WESTSIDE SUBWAY EXTENSION PROJECT

Contract No. PS-4350-2000

Reply to Exponent Responses

May 15, 2012

Figure 1: Buildings Indicated to Be Demolished at BHHS

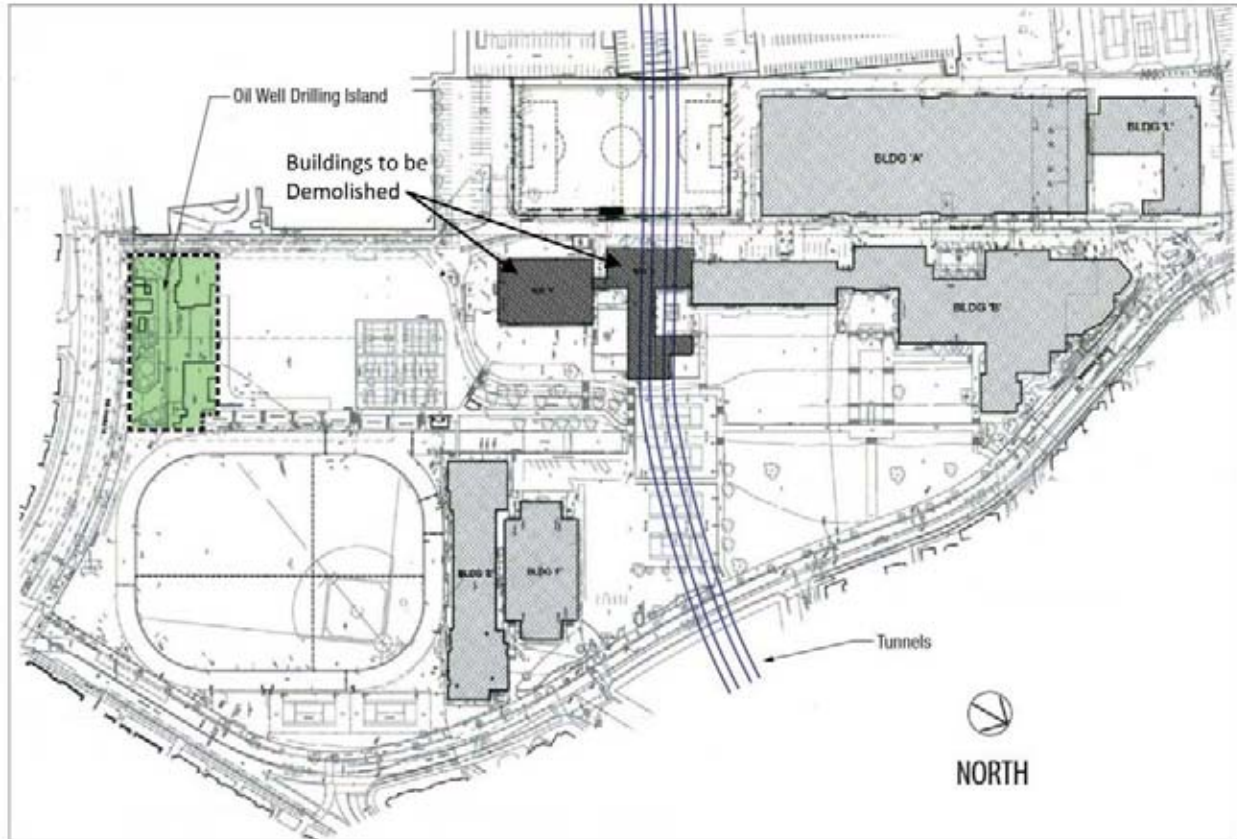
Exponent states: *"Exponent expresses concern for potential ground settlements and impacts on the BHHS building if the TBM is stopped beneath the building in order to abandon an oil well casing."*

Metro response: Should an oil well casing be found to be located along the alignment and beneath a current BHHS building, several alternatives will be considered. The situation lends itself to full cooperation between Metro and BHUSD for an opportunity to explore the site conditions for the purpose of mutually optimizing the interaction of tunneling and future development of the high school. BHHS plans for future development (Modernization Plan 2009, Figure 1) show that the portion of the building beneath which the tunnel would be advanced would be removed. In this case, access for well abandonment and casing removal would be gained from the surface prior to tunneling. If the existing building were to remain in place, should a well casing be detected, consideration would be given to either adjusting alignment slightly to avoid a casing or to gaining access using ground control procedures, such as grouting or freezing, to excavate and remove the casing prior to tunneling without impacting the buildings above. It is emphasized that the probability of encountering an oil well on the tunnel alignment and directly under the school buildings is very low. There is no evidence from available Division of Oil, Gas, and Geothermal Resources records or from historic photos of the existence of oil wells under the BHHS buildings along the proposed alignment.

Figure 2: Figure 8-1 from Metro Tunneling Safety Report

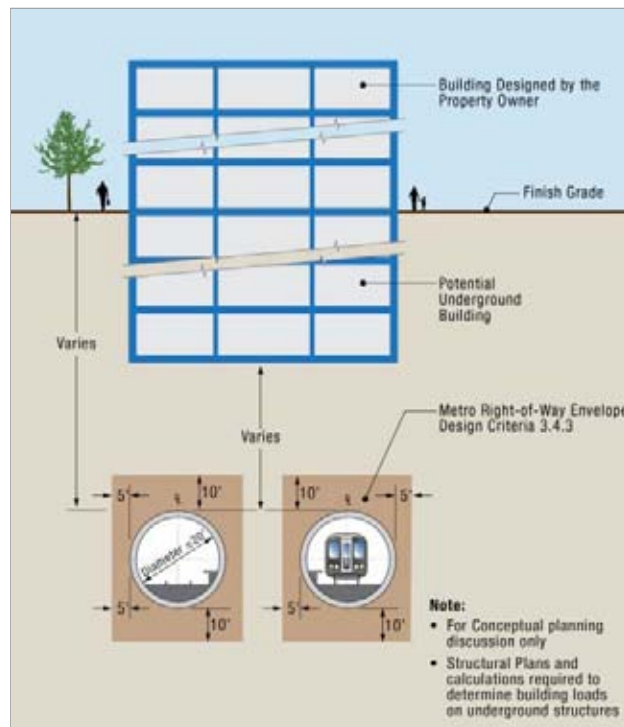
Exponent states: *“On page 7-1 of their Response Report, Metro states that special foundations would not be required for structures placed above the tunnels. However, this would be true only for future structures that lie above or outside of Metro’s Right-of-Way Envelope. The preliminary tunnel profiles under BHHS show the tunnel crown to be approximately 55 to 70 feet below grade, leaving approximately 30 to 50 feet of clearance for underground structures and foundations. This amount of clearance may be sufficient for two to four levels of underground parking on a mat foundation. However, other types of structures may require different foundations that consist of piles or drilled piers that extend into Metro’s Right-of-Way Envelope. In the Response Report, Metro states that ‘Any future project to be developed adjacent to Metro right-of-way will need Metro approval prior to construction.’ Closer guidance and expectations should be provided by Metro about any construction approval processes required by them.”*

Metro response: This topic was covered in Metro’s Tunneling Safety report (Section 8.0), but it appears that there are misconceptions regarding Metro’s Right-of-Way Envelope and requirements for locating structures above and adjacent to Metro tunnels. Guidance on the construction approval process can be found in Metro’s *Adjacent Construction Design Manual* (R9-DE303-3.00). Review of proposed designs that could have a direct impact on a Metro facility or structure is required, but specific requirements for offsets and stand-off distances from the tunnels are not given because each project—and its relationship to the Metro facility—is unique and solutions need to be made on a case-by-case basis. Metro looks forward to the opportunity to work with BHHS to develop acceptable solutions for proposed foundations or underground facilities in the vicinity of the tunnels.

Metro Rail Civil Design Criteria defines right-of-way limits for earth tunnels for real estate acquisition purposes, as shown in Figure 2 reproduced from the Metro Tunneling Safety Report.

- Major bridge-like structures with wide spans to support foundations above the tunnels are generally not required.

- Near-surface structures with shallow foundations and basements can be constructed above the tunnels. Clearances above the proposed tunnel crown are sufficient for multiple levels of underground parking.
- Construction of basements or underground parking structures on mat foundations reduces the load on underlying structures, making it feasible to place the foundation mat in close proximity to the crown of the underlying tunnel. The weight of the soil removed is usually more than the weight of the structure.
- Deep foundations, such as drilled piers, can be placed adjacent to, and between, the tunnels.
